HEARING EXAMINER PUBLIC HEARING AGENDA

1. **DSR25-009: Design Review with the Hearing Examiner for the construction of a new PreK-8 school and office building and associated site improvements, including construction of a trash enclosure, parking lot reconfiguration, installation of utilities, a play area, and pedestrian pathways, and removal and replacement of trees.**

RE: Herzl-Ner Tamid Conservative Congregation (Barnabie Point Project) Design Review DSR25-009	FINDINGS OF FACT, CONCLUSIONS OF LAW AND FINAL DECISION
--	---

Staff Finding: The proposed screening is shown in the landscape screening diagram in **Exhibit 3, Sheet A-011** and below.

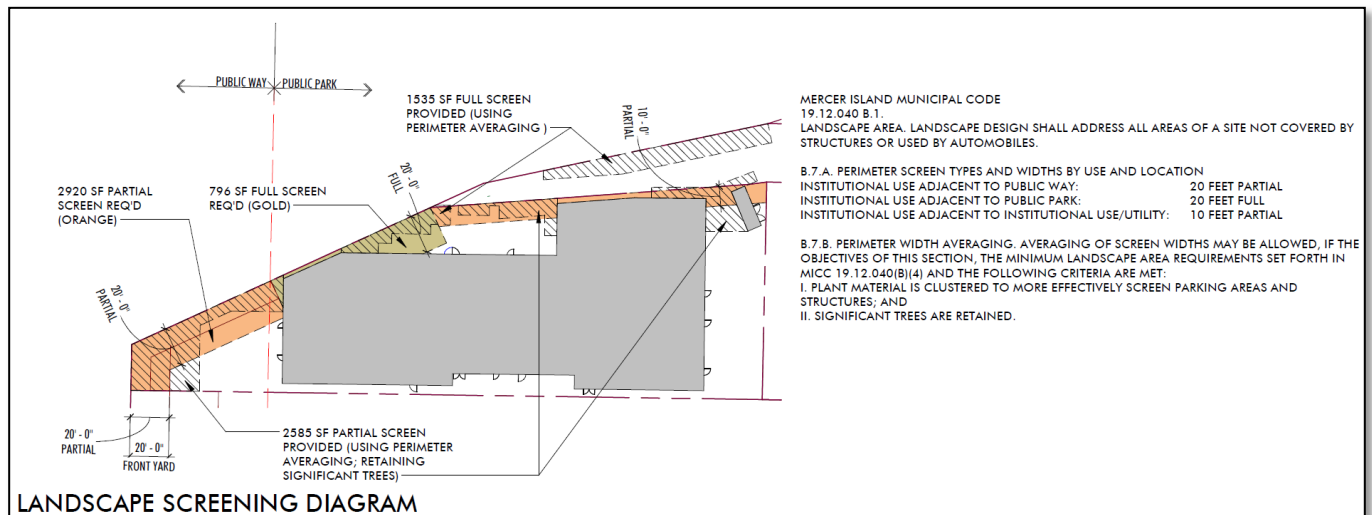
Staff Finding: The applicant proposes to include perimeter width averaging in the hatched areas shown in the landscape screening diagram in **Exhibit 3, Sheet A-011**. The proposed plant material would be clustered to more effectively screen the proposed structure while retaining some significant trees on the site.

Staff Finding: Full screening is provided on the north side of parcel 0824059045 and parcel 151560TRCT for the institutional use adjacent to the public park on parcel 0824059310. The existing PSE vehicle access on parcel 151560TRCT would not be obstructed by the proposed landscape screening. The proposed trees provided are proportionate to one tree for every ten feet of landscape perimeter in length as shown in the west enlarged site plan in **Exhibit 3, Sheet A-011**. A condition of approval is recommended to ensure the screen blocks views from adjacent properties at the pedestrian eye level in all seasons within three years of installation.

Staff Finding: Partial screening would be provided on the west and north sides of parcel 0824059045 where the institutional use is adjacent to the public way and other institutional uses/utilities. The screening would provide moderated vegetated separate between the public way and utility uses, and intermittent views to adjacent properties, as shown in the west enlarged site plan in **Exhibit 3, Sheet A-011**. A condition of approval is recommended to ensure the screen provides the desired screening function as seen at the pedestrian eye level in all seasons within three years of installation.
